SUNDRY NOTICES AND REPORTS ON WELLS (DO NOT USE THIS FORM FOR PROPOSALS TO DRILL OR TO DEEPEN OR PLUG BACK TO A DIFFERENT RESERVOIR. USE "APPLICATION FOR PERMIT" (FORM C-101) FOR SUCH PROPOSALS.)		WELL API NO. 30-015-48314
1. Type of Well: Oil Well ☒ Gas Well ☐ Other ☐		5. Indicate Type of Lease STATE ☒ FEE ☐
2. Name of Operator EOG Resources, Inc.		6. State Oil & Gas Lease No. 322721
3. Address of Operator P.O. Box 2267, Midland, Texas 79702		7. Lease Name or Unit Agreement Name Golden Graham 1 State Com
4. Well Location Unit Letter <u>N</u> : <u>215</u> feet from the <u>South</u> line and <u>1814</u> feet from the West line Section <u>1</u> <u>26S</u> Township <u>28E</u> Range <u>NMNM</u> Eddy County		8. Well Number <u>704H</u>
11. Elevation (Show whether DR, RKB, RT, GR, etc.) 2933' GR		9. OGRID Number <u>7377</u>
		10. Pool name or Wildcat 98220 Purple Sage; Wolfcamp (Gas)

EOG respectfully requests an amendment to our approved APD for this well to reflect the following changes:

Update casing and cement program to current design.

Golden Graham 1 State Com #704H

Design B

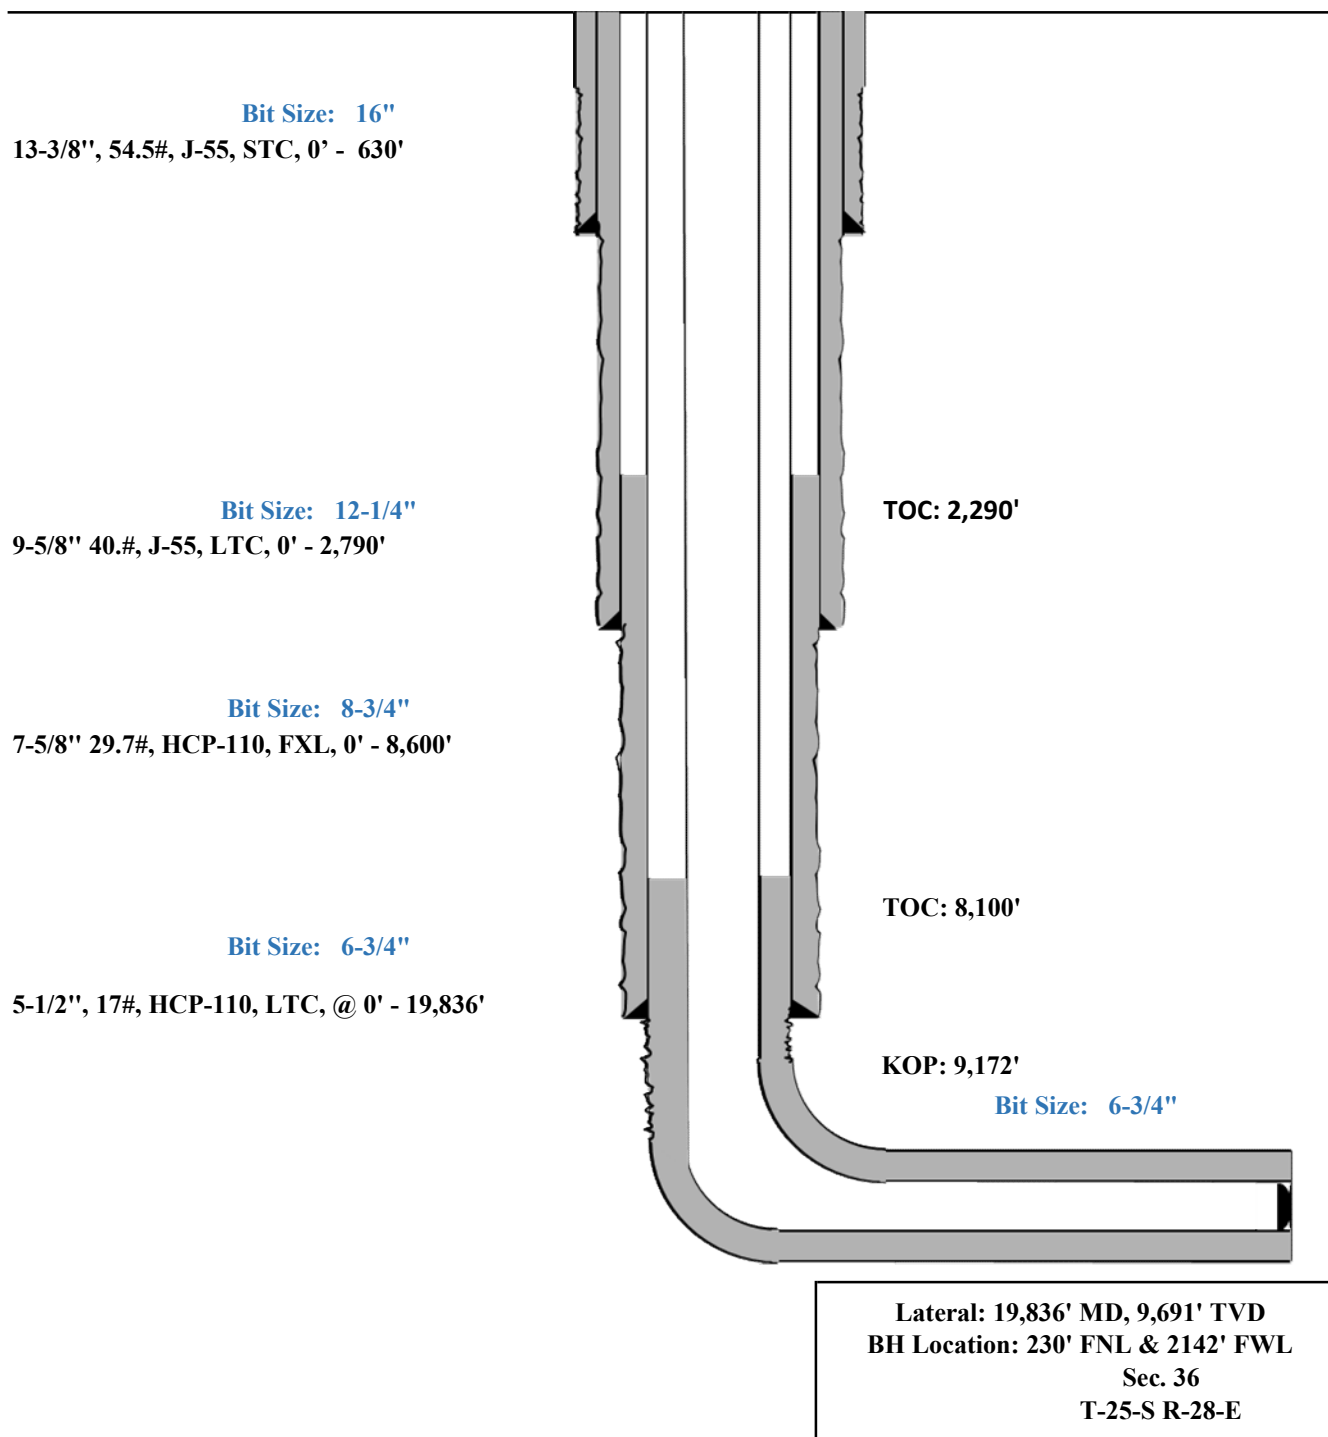
As a contingency, EOG requests to pump a two stage cement job on the 7-5/8" intermediate casing string with the first stage being pumped conventionally with the calculated top of cement at the Brushy Canyon (4,818') and the second stage performed as a bradenhead squeeze with planned cement from the Brushy Canyon to surface. If necessary, a top out consisting of 1,000 sacks of Class C cement + 3% Salt + 1% PreMag-M + 6% Bentonite Gel (1.5 yld, 14.8 ppg) will be executed.

Hole Size	Interval	Csg OD	Weight	Grade	Conn	DFmin Collapse	DFmin Burst	DFmin Tension
16"	0' - 630'	13.375"	54.5#	J-55	STC	1.125	1.25	1.6
12.25"	0' - 2,790'	9.625"	40#	J-55	LTC	1.125	1.25	1.6
8.75"	0' - 8,600'	7.625"	29.7#	HCP-110	FXL	1.125	1.25	1.6
6.75"	0' - 19,836'	5.5"	17#	HCP-110	FXL	1.125	1.25	1.6

Depth	No. Sacks	Wt. ppg	Yld Ft3/sk	Slurry Description
630'	190	13.5	1.73	Lead: Class C + 4.0% Bentonite Gel + 2.0% CaCl ₂ (TOC @ Surface)
	100	14.8	1.34	Tail: Class C + 0.6% FL-62 + 0.25 lb/sk Cello-Flake + 0.2% Sodium Metasilicate + 2.0% KCl (1.06 lb/sk)
2,790'	420	12.7	2.22	Lead: Class C + 0.15% C-20 + 11.63 pps Salt + 0.1% C-51 + 0.75% C-41P (TOC @ Surface)
	190	10.8	1.32	Tail: Class C + 0.13% C-20
8,600'	180	14.8	3.67	Lead: Class H + 0.40% D013 + 0.20% D046 + 0.10% D065 + 0.20% D167 (TOC @ 2,290')
	100	14.8	2.38	Tail: Class H + 94.0 pps D909 + 0.25% D065 + 0.30% D167 + 0.02% D208 + 0.15% D800 (TOC @ 7,104')
19,836'	1000	14.8	1.31	Class H + 0.1% C-20 + 0.05% CSA-1000 + 0.20% C-49 + 0.40% C-17 (TOC @ 8,104')
